**TOWN OF HERNDON, VIRGINIA
HERITAGE PRESERVATION REVIEW BOARD
WORK SESSION AGENDA
DECEMBER 4, 2019
HERNDON COUNCIL CHAMBERS BUILDING
765 LYNN STREET
7:00 P.M.**

2. **APPLICATION FOR A CERTIFICATE OF APPROPRIATENESS FOR AN ALTERATION TO AN EXISTING STRUCTURE, HPRB #19-34**, to consider an application for a Certificate of Appropriateness for the installation of a new windows on an accessory structure on the single family residential property at 744 Dranesville Road, Herndon, Virginia, located between the intersection of 3rd Street and Dranesville Road and the intersection of Worchester Street and Dranesville Road, and further identified as Fairfax County Tax Map 0104-02-0061A. The property is zoned R-10, Residential, Single Family; and consists of 91,685 total square feet of land. Owners/Applicants: William H. Wright, Jr. and Carol W. Wright. Applicants' Representative: Liz Lee, Moss Building and Design.

3. **APPLICATION FOR A CERTIFICATE OF APPROPRIATENESS FOR AN ADDITION TO AN EXISTING STRUCTURE, HPRB #19-37**, to consider an application for a Certificate of Appropriateness for the replacement of a two-story elevator with an enclosure, replacement of a mechanical equipment enclo

Exterior Elevation

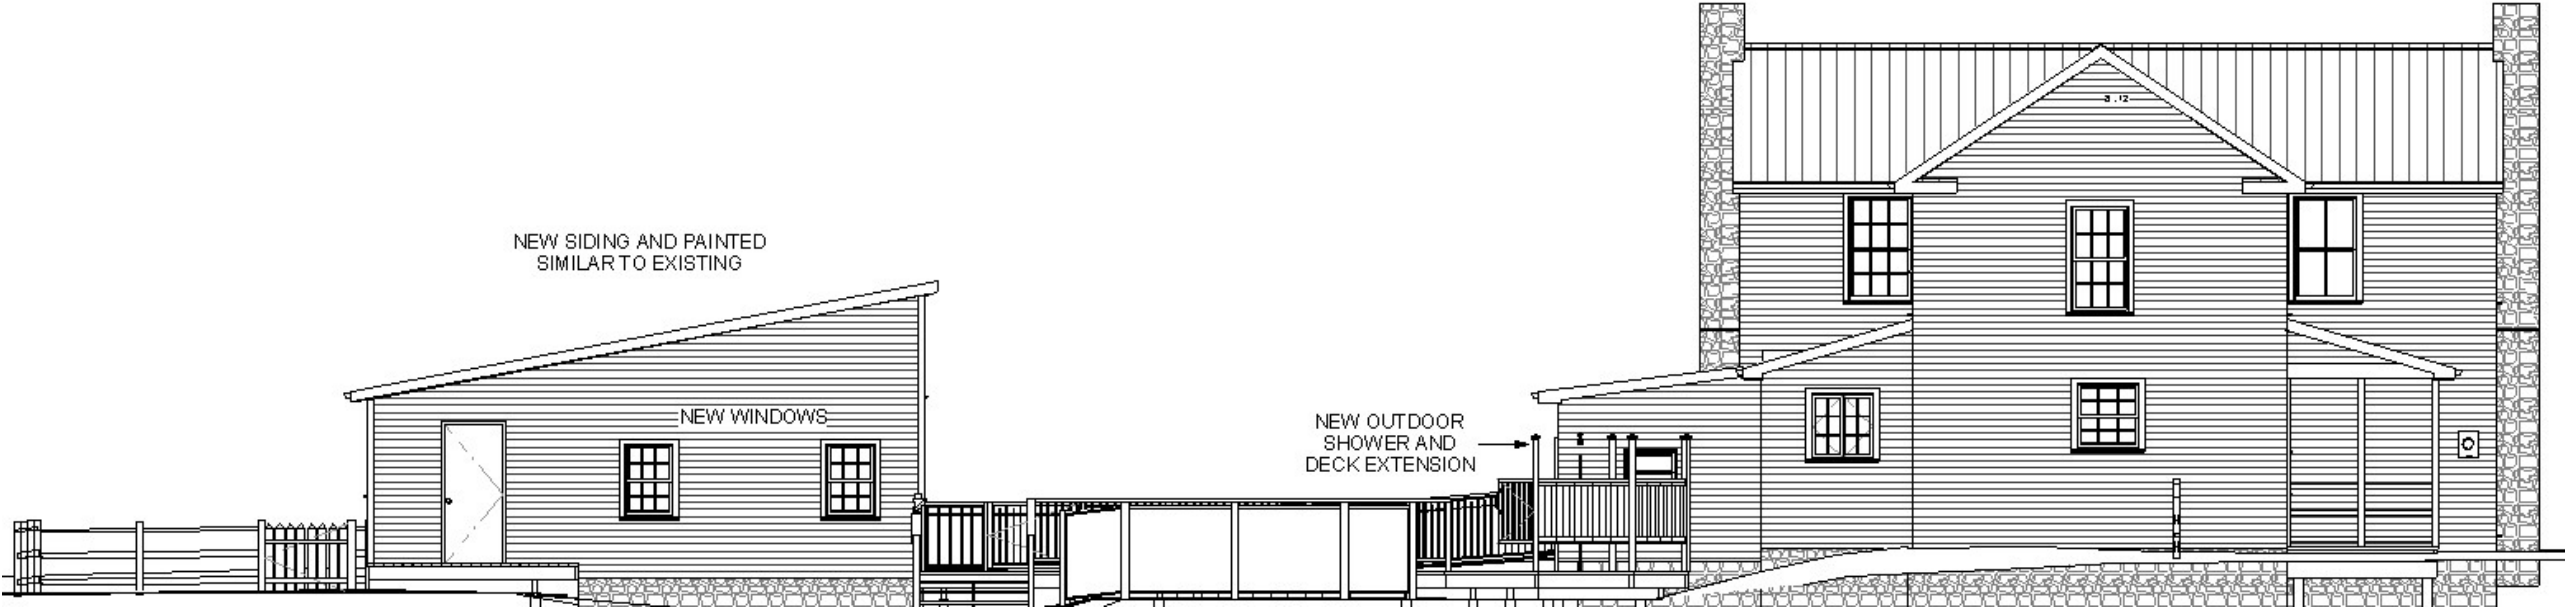
This application proposes to install two new 29" X 47" wood, double hung windows on the north elevation of the accessory structure located to the north of the primary residential structure on the subject property. The two new wood windows will be selected from the Pella® Architect Series Reserve in a pre-finished white color to match the existing window colors on the primary and accessory structure with wood muntins and a 6-over-6 light division pattern to match several window types currently found on both structures (Attachments #1, #2, and #3).

1. Within the Heritage Preservation Handbook, Chapter 13 Rehabilitation Guidelines: Windows, guidelines for window replacement, repair and maintenance are specified. While this project is altering the number and location of windows on the secondary structure, the new proposed windows are being selected to reflect the planned replacements of existing windows of the same materials and design as described in the administrative approvals case, HAA #19-018. The proposed window type and material is a common double hung wood window using a common (to the Heritage Preservation Overlay District) six-overs-six lite division pattern with wood muntins as is currently found on the primary residential and accessory buildings guidelines in this section generally states:

- a. Numbers, sizes, location and or glazing patterns should not be changed;
 - b. Avoid cutting new opening, infilling window openings, and installing new window sizes that do not fit the original windows;

The referenced guidelines form a rational basis for determining the appropriateness of replacement or reconstruction of existing windows. While the standards are written for prevent inappropriate alterations, the guidelines do not accommodate specifically for the changes of the use of interior spaces, more specifically as that would apply to an accessory structure. In this case, the change in use of the interior space has been altered over time as the necessity for a barn has changed due the lack of necessity of keeping livestock or other externally agrarian uses that have diminished or altogether disappeared.

Staff finds that, in general, the proposed alterations are in keeping with the intent of the design guidelines of the Heritage Preservation Handbook due to the: (1) location of the alterations on a side façade of the accessory structure which is not visible from the adjacent street, (2) use of a typical stylistic elements of the windows and the building's original architectural style, and (3) use of very similar, if not identical, sizes/proportions and materials for the new windows.

Scope of Work:

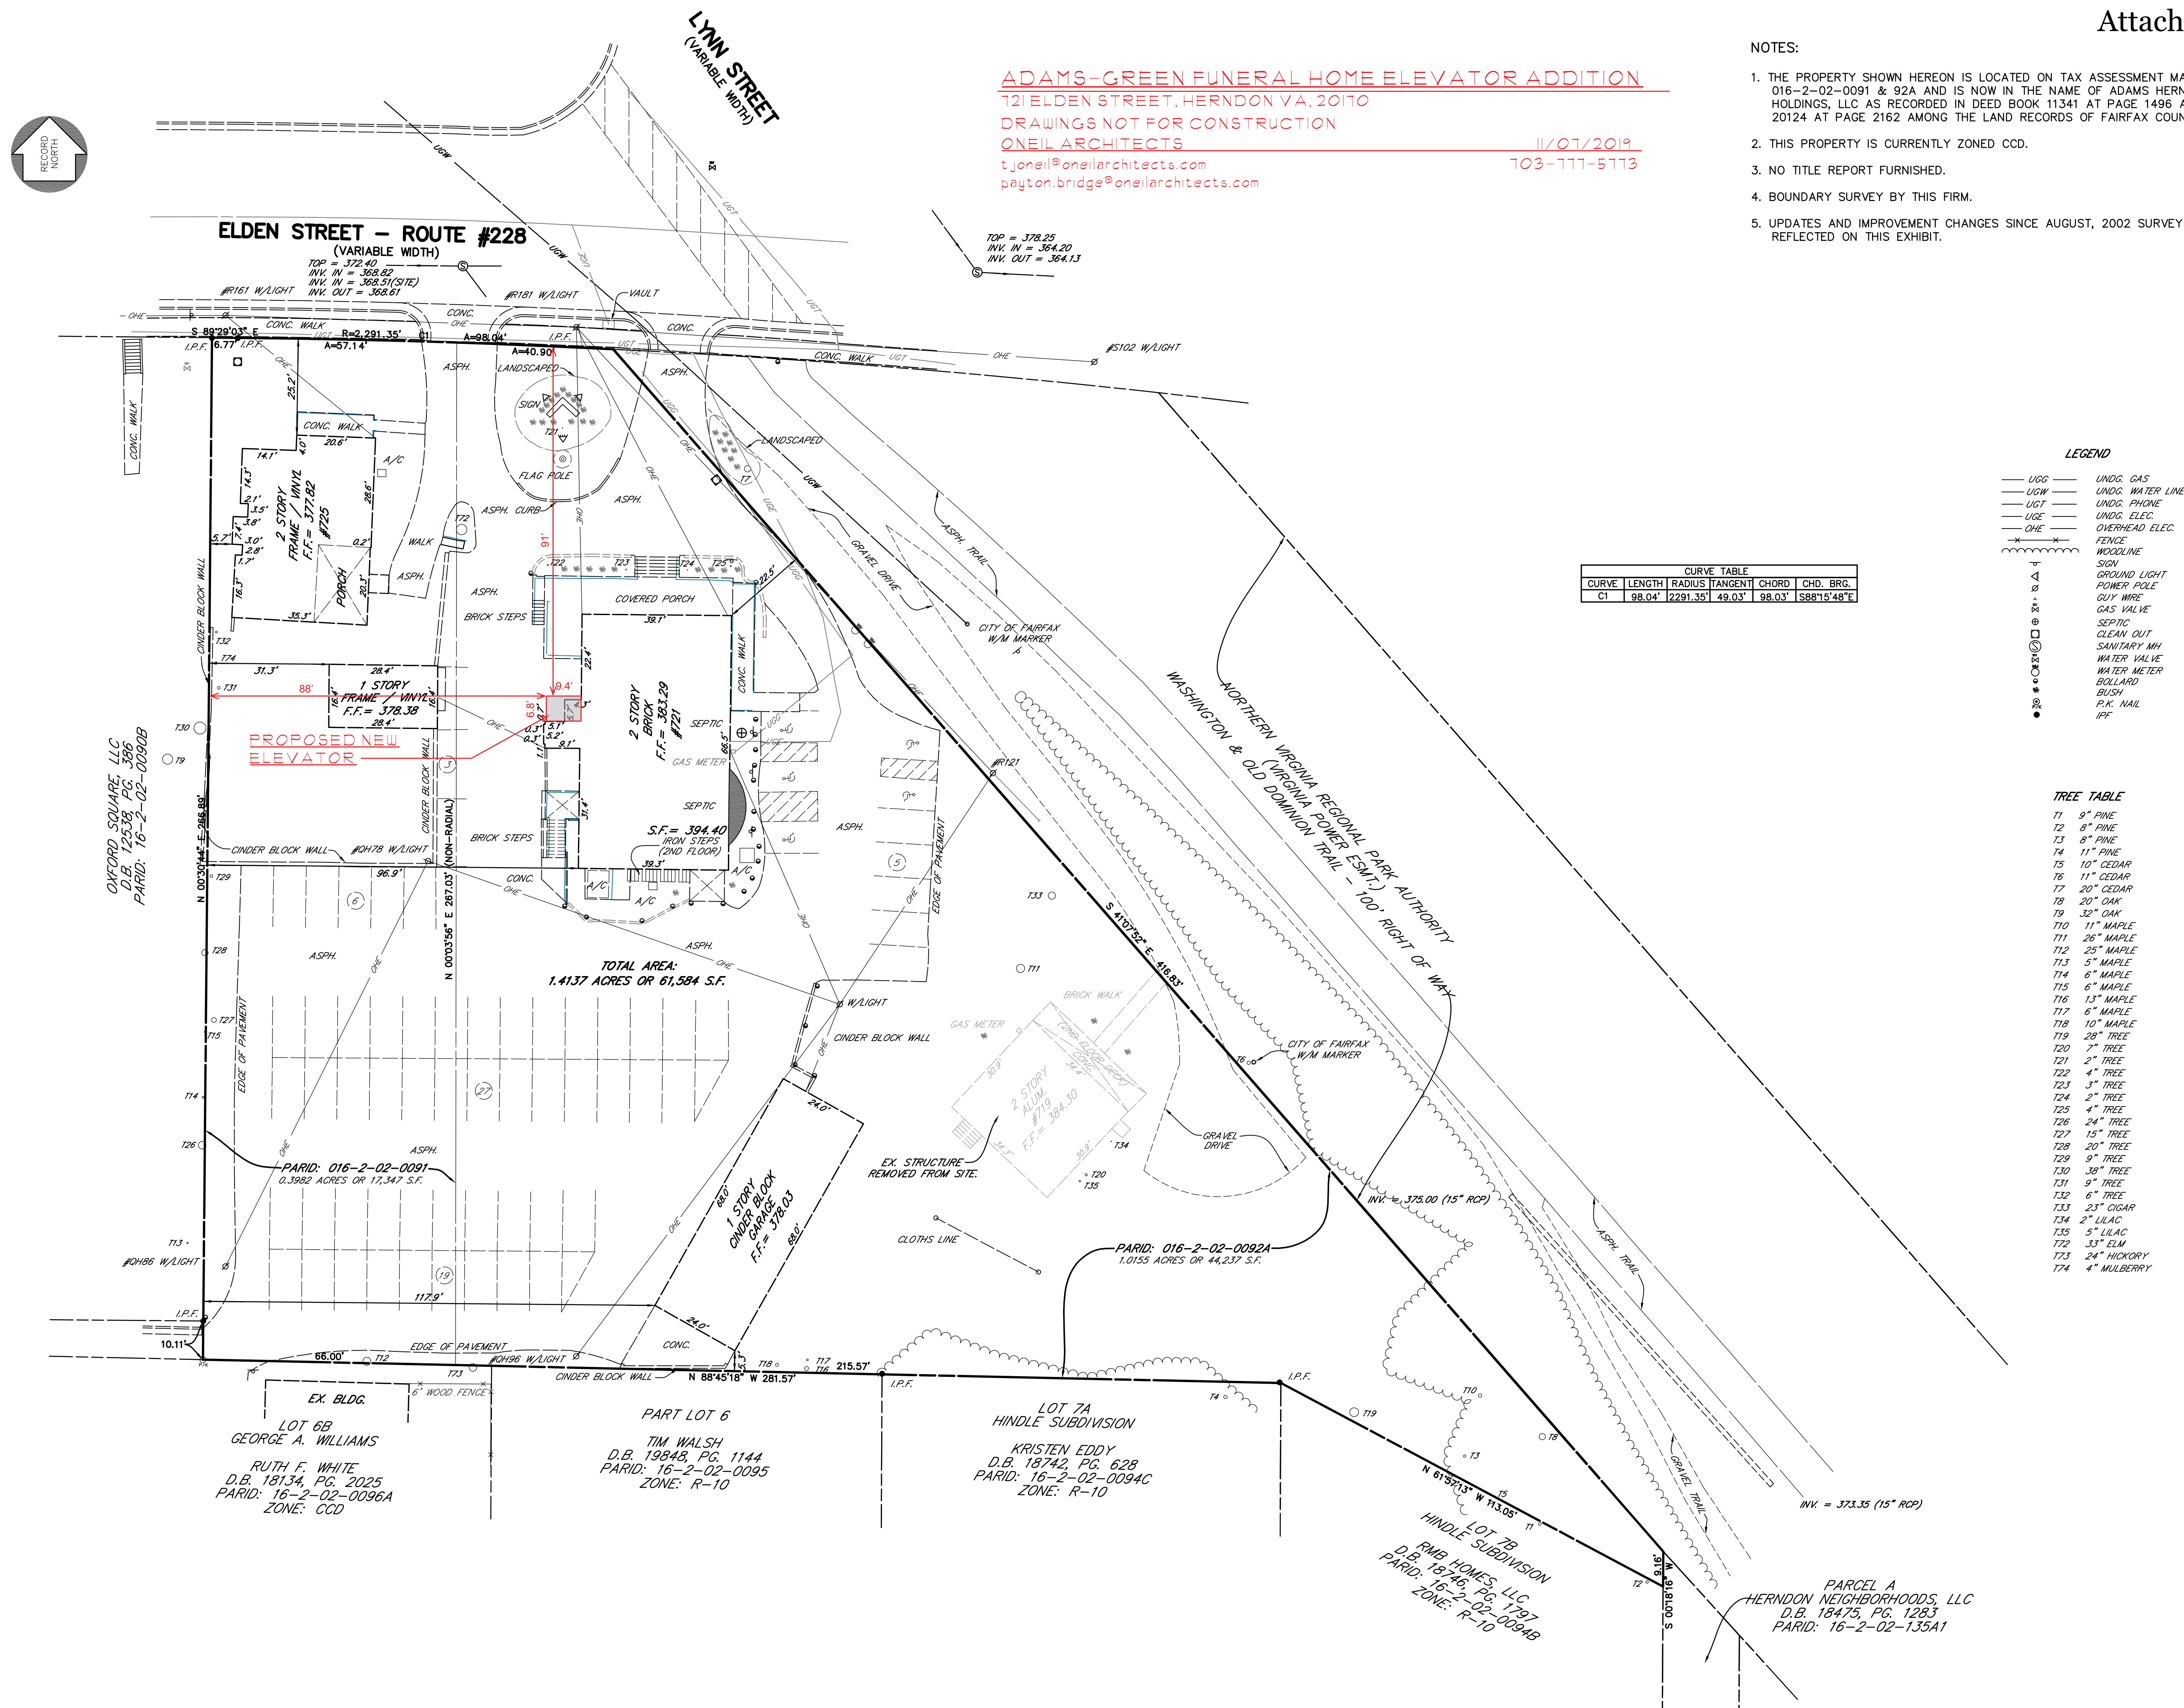
- a. The proposed elevator shaft and enclosure would require the removal of two existing original windows, partial removal of the roof eave, and partial removal of parts of the brick wall treatment. This change thus results in a direct reduction in historic fabric and integrity, and a change to original architectural features.

2. Staff is unable at this time to recommend approval of this addition as proposed based on the issues outlined above. If the applicant addresses the comments with a revised design, staff may be able to recommend approval or a conditioned approval dependent the further evaluation of a possible redesign.
